RELIEF AND RECONSTRUCTION
FUNDED WORK AT MOSUL DAM
MOSUL, IRAQ

SIGIR PA-07-105
OCTOBER 29, 2007

SUBJECT: Report on Relief and Reconstruction Funded Work at Mosul Dam, Iraq
(Report Number SIGIR PA-07-105)

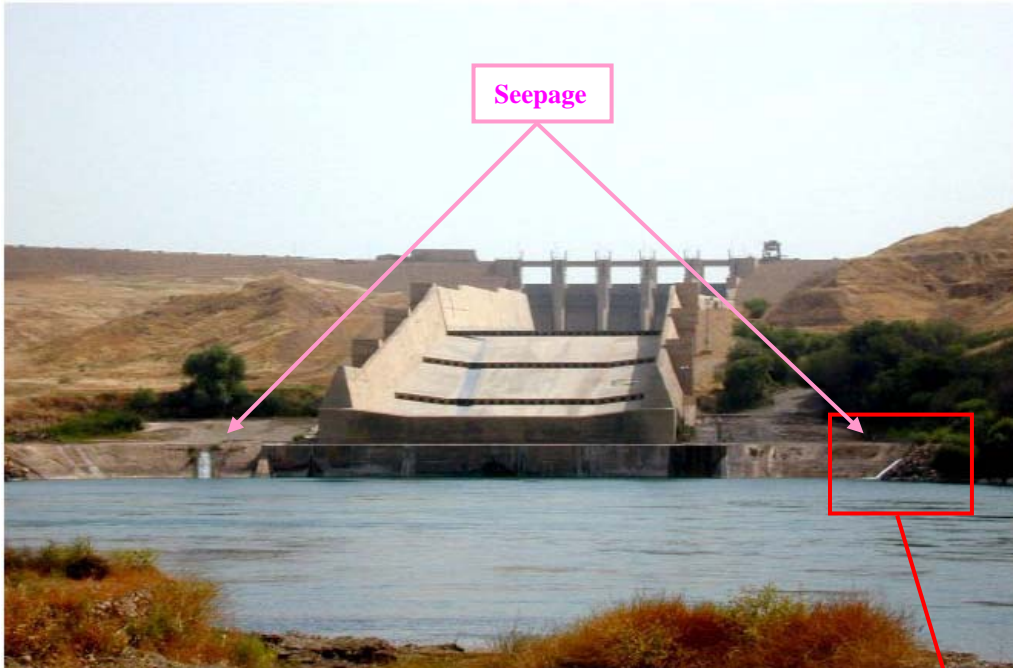
Page 9, Figure 6. We are not aware of seepage points that pass through the main embankment. Field observations did not identify seepage points in the main body of the dam as shown in the figure. Please either remove the figure or provide reference to the source of the figure and the analysis used to identify these seepage points.

Figure 6. Illustrative example of the Mosul Dam’s grouting program aimed at filling voids and cavities from the gallery (Figure courtesy of USACE)

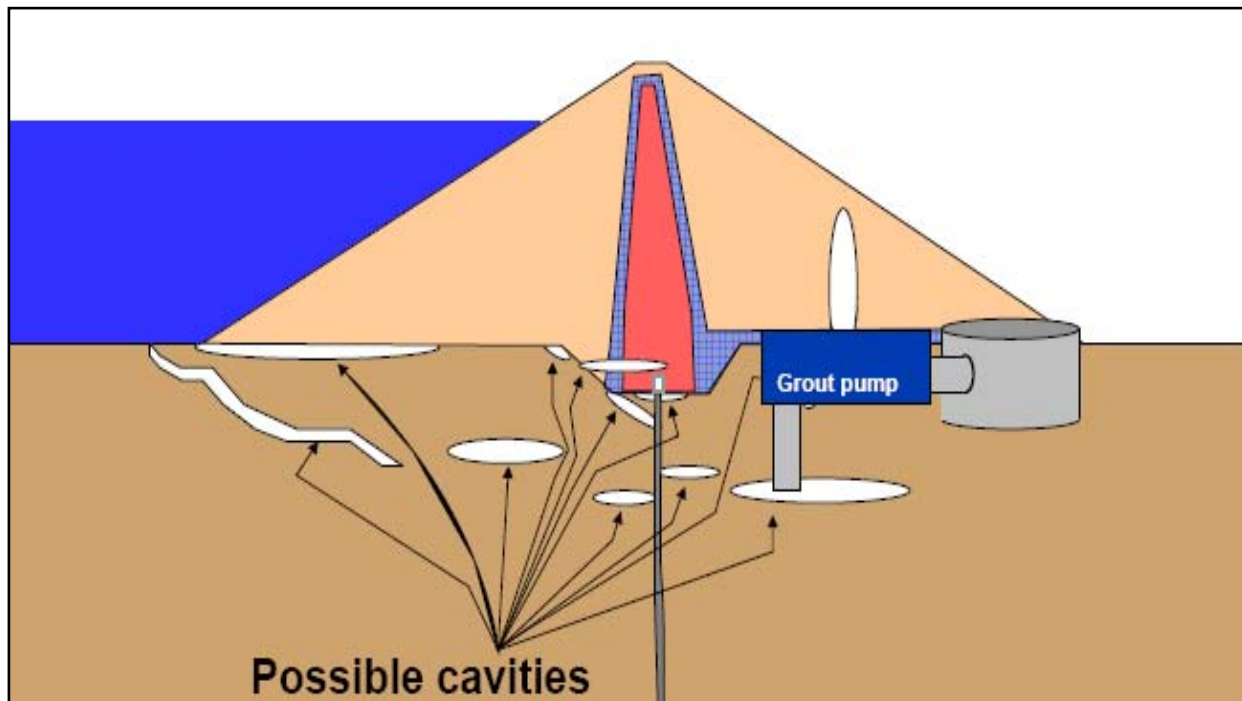
Page 10, Figure 7. Mosul dam engineers do not have means of “filling cavities” away from the grouting gallery. Figure 7 shows a grout pump filling a cavity downstream from the gallery; there is no means available to achieve this. Grouting can only occur from the grouting gallery. Suggest removing this figure.

Figure 12. Contractor's design drawing for 30-m³/hour concrete-mixing plant

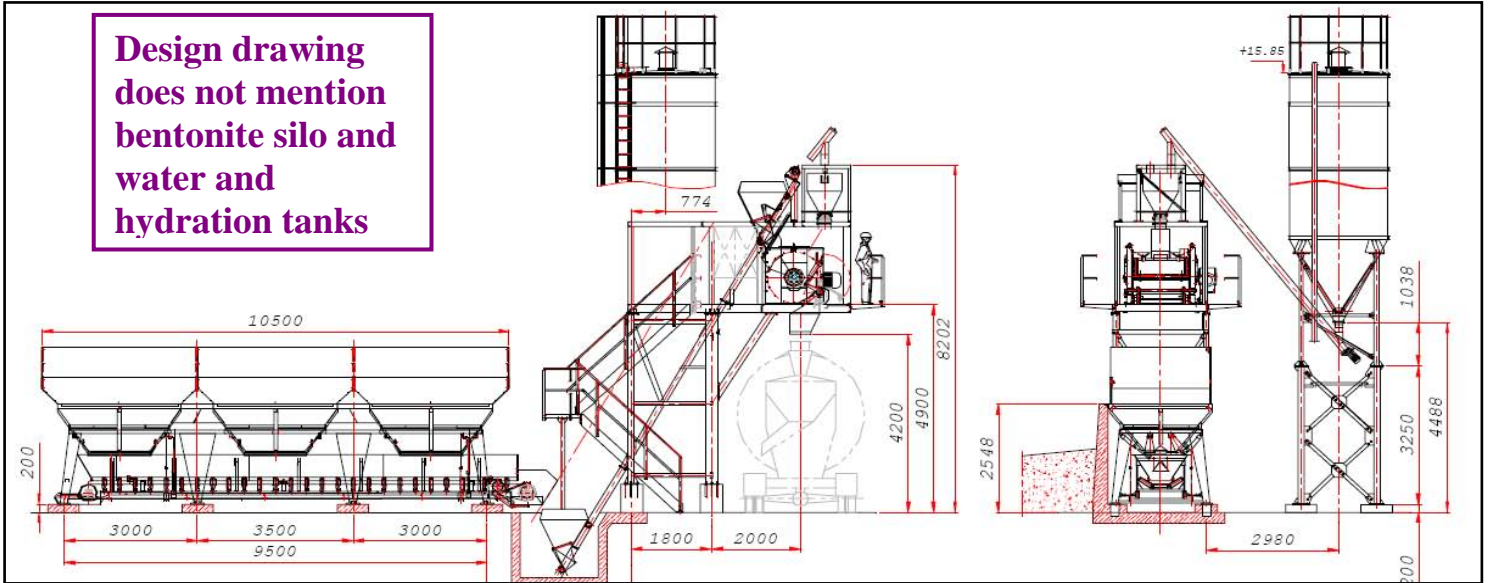
GRD provided the contractor's design submittals for the two sizes of grout-mixing plants (i.e., 30-m³/hour and 100-m³/hour), which we reviewed. For the 30-m³/hour grout-mixing plants, our review of the design drawings concluded that the contractor was clearly offering concrete-mixing plants, not grout-mixing plants (Figures 12 and 13). Grout mixing plants require a bentonite silo and water and hydration tanks, associated weighing and measuring devices, additional pumps and motors, which were not included in the design drawings.

Figure 13. Contractor's design drawing for 100-m³/hour concrete-mixing plant

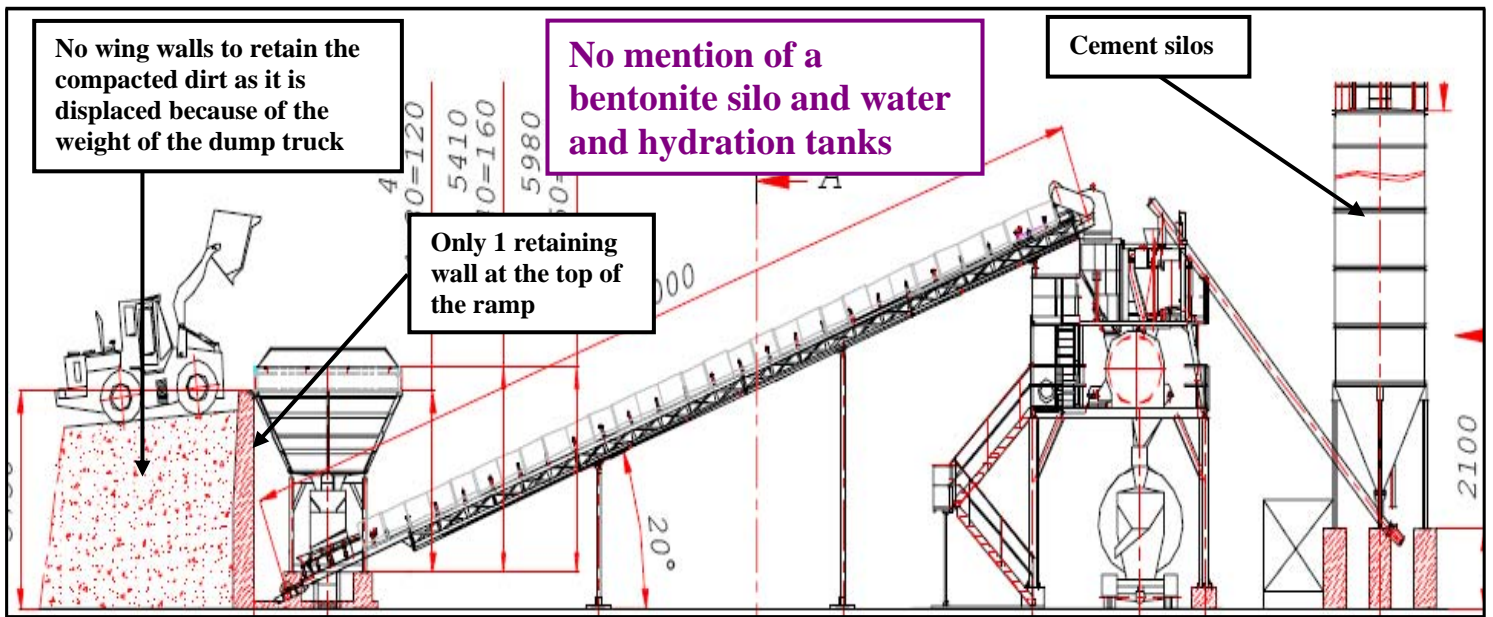
In our opinion, the 100-m³/hour mixing plant design submittal also clearly indicated the contractor was offering a concrete-mixing plant, not a grout-mixing plant (Figure 15). The design submittal lacked a bentonite silo, water and hydration tanks, associated weighing and measuring devices, and additional pumps and motors, which are essential for a grout-mixing plant (Figure 13).

The July 2006 CH2MHill/Parsons’ memorandum did not mention the 100-m³/hour grout-mixing plant. The contract file lacked any documentation regarding how the concrete-mixing plant was reviewed and approved instead of the required grout-mixing plant. It appears that for the 100-m³/hour grout-mixing plant design submittal, the EC also did not “notice” the contractor’s submittal offer was for a concrete-mixing plant, not a grout-mixing plant. In addition, the EC did not recognize the contractor’s design submittal lacked side retaining walls (i.e. wing

walls) for the loading ramp (Figure 13). The wing walls are crucial for the use of the loading ramp because without them, when the full dump truck drives up the ramp, the compacted dirt will disperse under the truck's weight resulting in the truck not being able to reach the hoppers to unload the materials.

Figure 16. Top view of four stationary silos

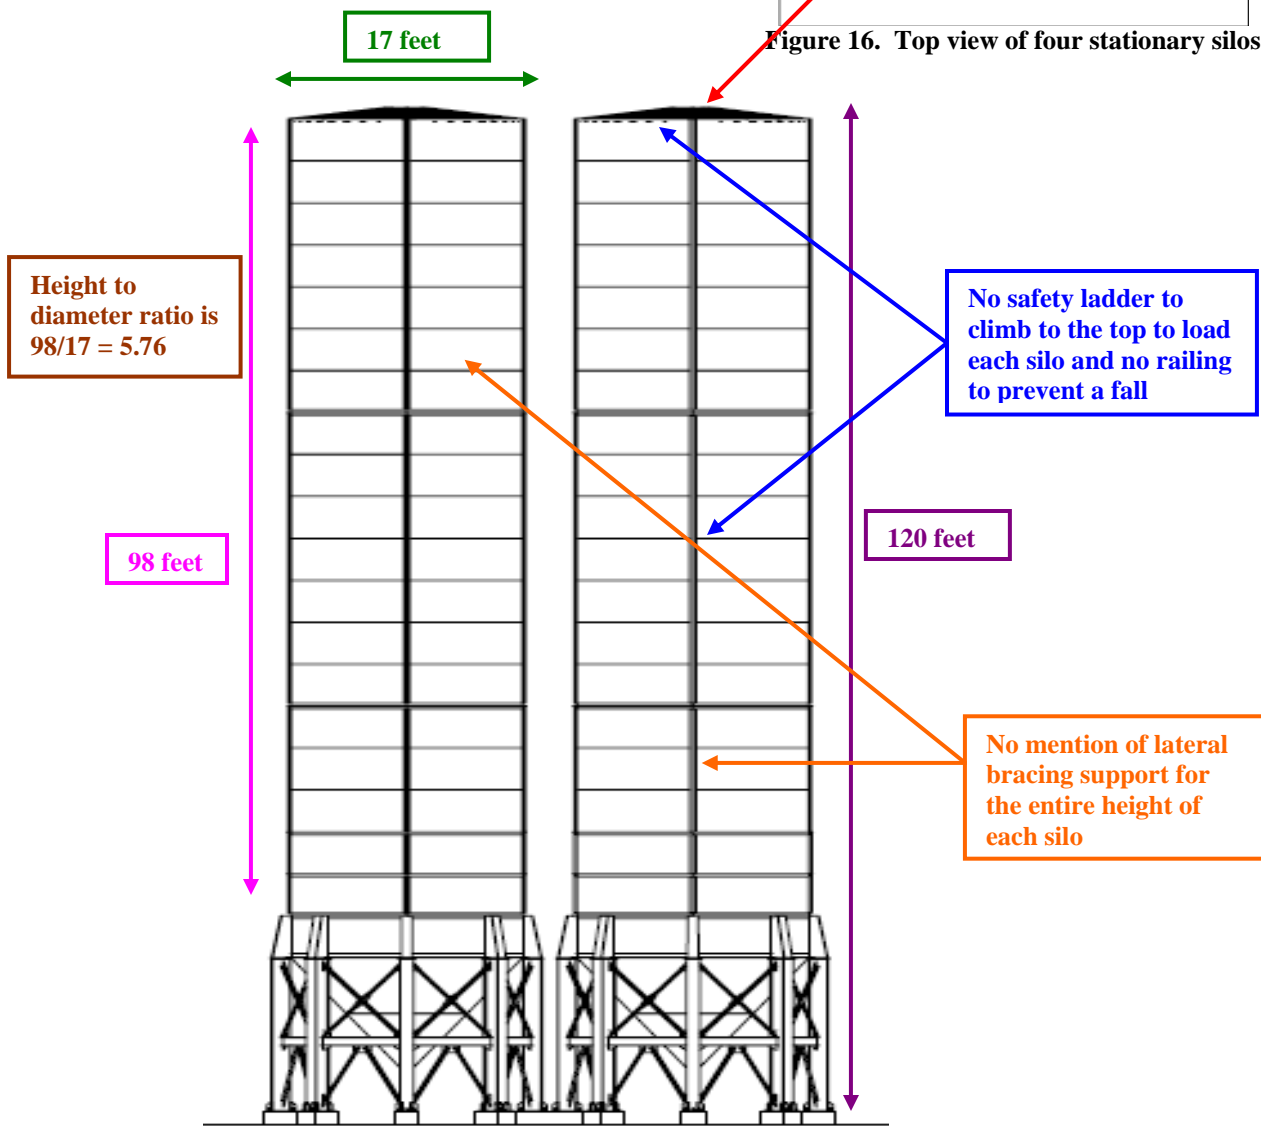
The "Plans and View [sic]" design submittal provided multiple views of the finished stationary silo (Figures 16 and 17). According to the design drawings, each silo was to be approximately 120 feet high (from the base to the top). After thoroughly reviewing all available design drawings, we found the designs lacked significant details, such as lateral bracing support for the entire height of the silos (Figure 19), notes for the thread size, length, washer size, base plate requirement, and torque (for the foundations bolts – Figures 18-21), how the MWR personnel will deposit cement into the silo, and safety concerns. The lateral bracing supports for the entire height of each silo are important in order to keep each silo in its intended vertical position while allowing the load to transfer to the matt foundation during the cement filling process. The proportion of the silos is very large, since the height to diameter ratio is almost 6 (Figure 17), which could result in the silos overturning. According to an internal GRD document, the "standard practice is to resist overturning by a ratio of 1.5." A consulting engineer for GRD stated the silos looked like an "inverted pendulum." Further, detailed information for the foundation bolts is critical, since the foundation bolts will be required to counter all gravitational forces that would cause the silo to tip over, under most conditions. Further, since the opening to fill each silo is located at the top (120 feet high), for safety reasons, we are concerned that the contractor's designs did not include a safety ladder to climb or a safety bar and railing at the top (Figure 17). Additionally, no secure walkway with safety railings is shown to connect all silos at the top.

Loading each silo occurs at the top

Height to diameter ratio is $98/17 = 5.76$

Figure 18. View of column group for the stationary silos

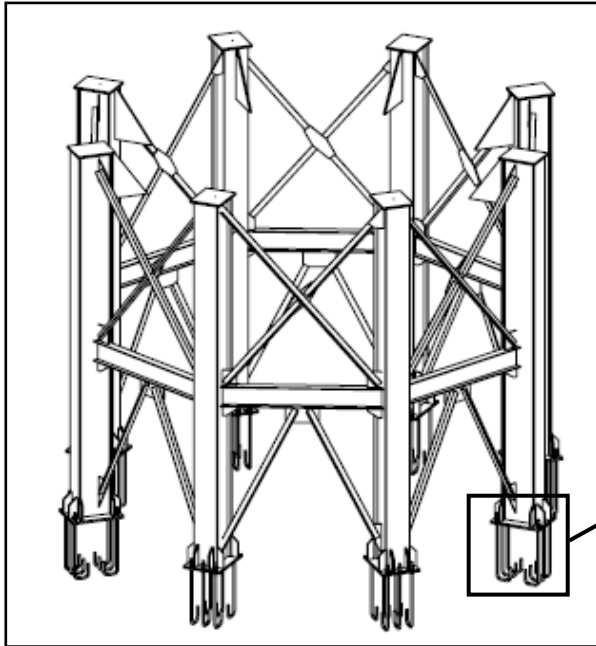
Design does not mention diameter size, thread size and length and strength grade for steel

Figure 28. Requirements of the design drawings

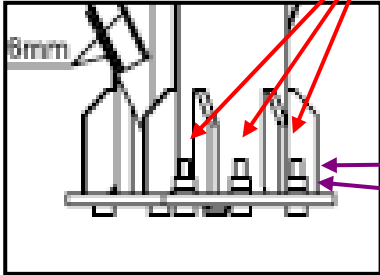
Contractor's design drawings required bolt threads extend beyond the nut and washer
